ZONING COMMISSION FOR THE DISTRICT OF COLUMBIA

CASE NO. 16-23 (Valor Development, LLC – Voluntary Design Review @
Square 1499, Lots 802, 803, 806 and 807)

Testimony of Neighbors for a Livable Community

January 24, 2019

¹ October 16, 2018, Valor Submission of Revised Plans and Supporting Information. Sheet G05.

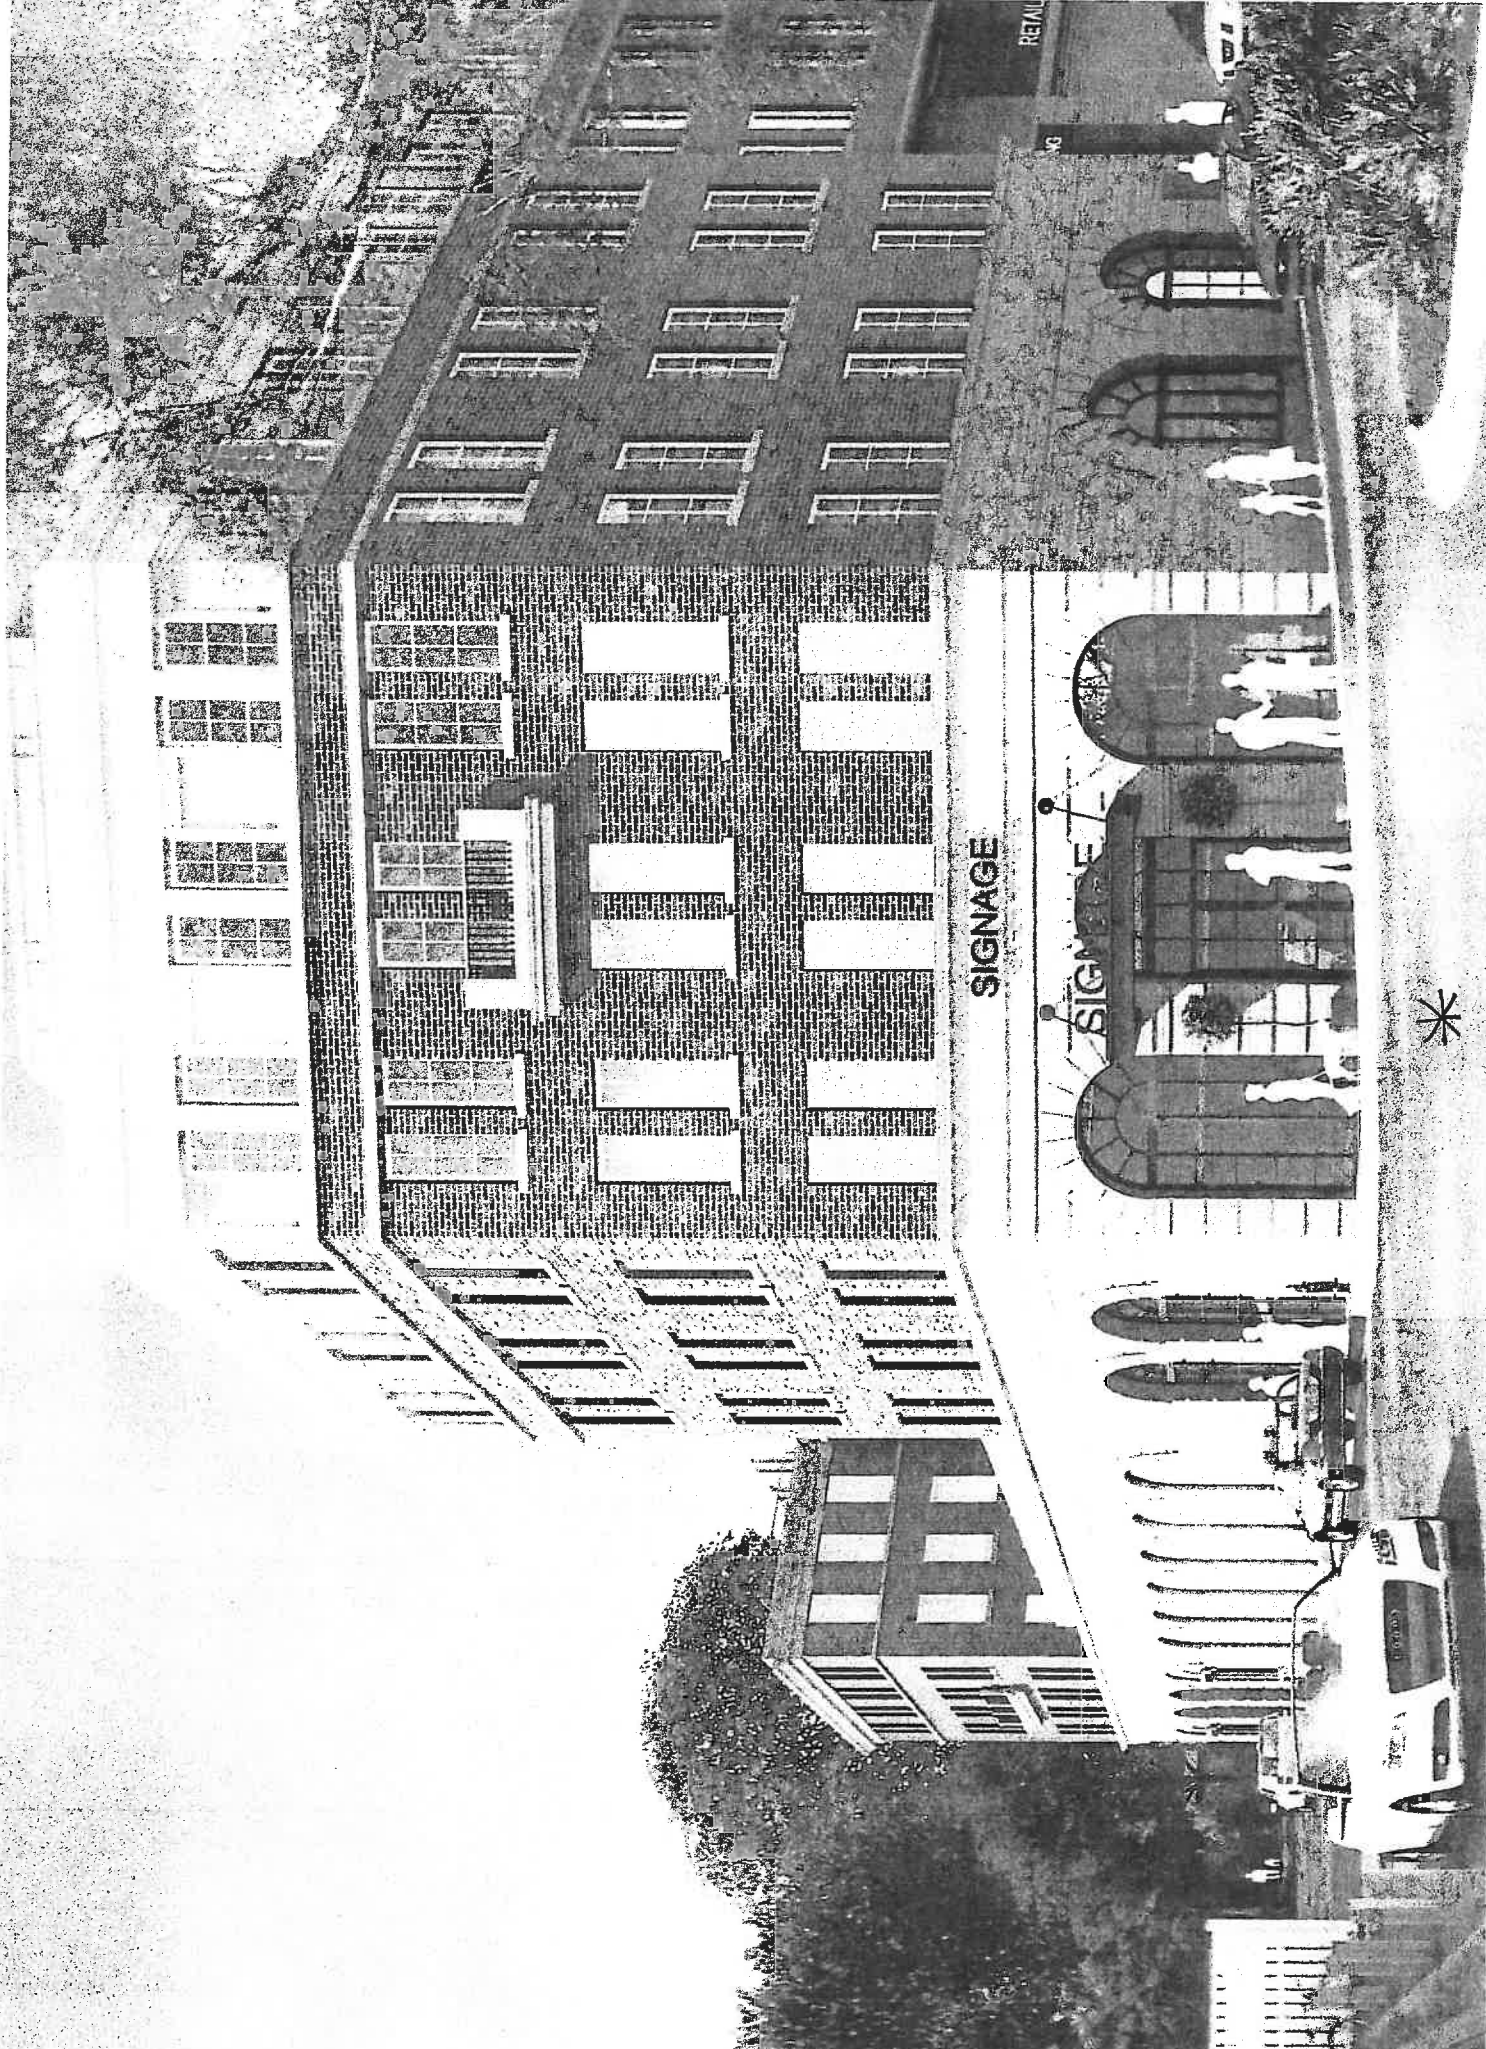
The Applicant, with the help of OP, attempts to convince the Zoning Commission that this is not a density transfer – it is an aggregation, it says, there is no

additional density and therefore the Design Review regulations are not violated. Neighbors for a Livable Community do not accept that there is no increase in density through the transfer process; and, the Valor site is not a designated transfer or receiving zone. Hopefully the Zoning Commission recognizes this approval will be precedent setting and may require a rewrite of Section 600.1(e) of the Design Review criteria.
